E3633A-05B**S E R V I C E****N O T E**Supersedes:
E3633A-05A**E3633A DC Power Supply****Serial Numbers: MY51240075 to MY99999999****Metal Strap Kit for tightening loose bumper and for fitting rear lock link in side-by-side rack mounting****Parts Required:**

March 27, 2013

Figure 1: Top view 3mm gap observed between two different chassis designs

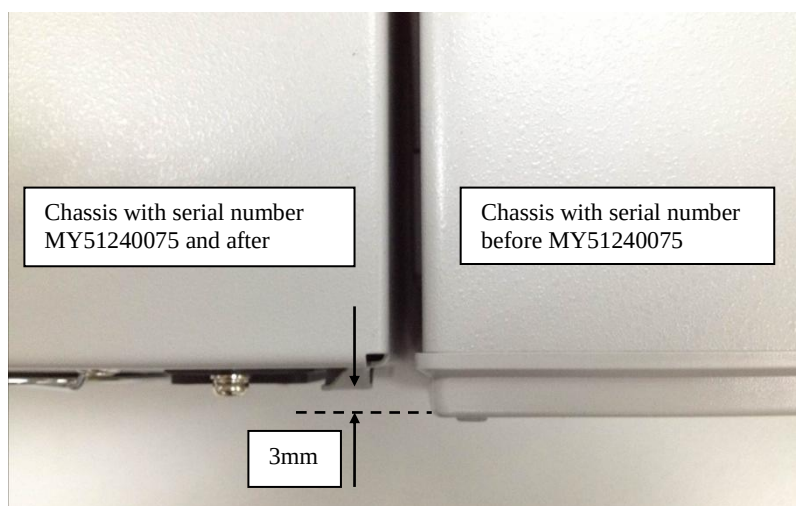
Situation 2:

The chassis depth difference between the two designs is 3mm as shown in Table 1 and Figure 1 below.

Figure 2: Top view 3mm gap observed on rear lock link for side-by-side rack mounting

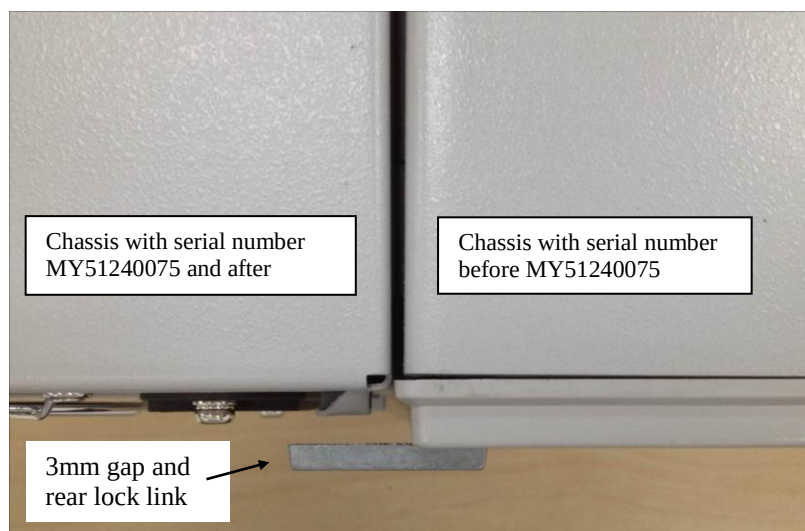
The 3 mm gap between the two different chassis may cause difficulties in securing them together using a rear lock link kit (part number 0050-2167) for side-by-side rack mounting as shown in Figure 2 below.

Solution for Situation 2

Use metal strap (part number E3631-07901), and stack the provided two metal straps together to form 3mm thickness and secure it with the provided screws on the rear lock link as shown in Figure 4 below.
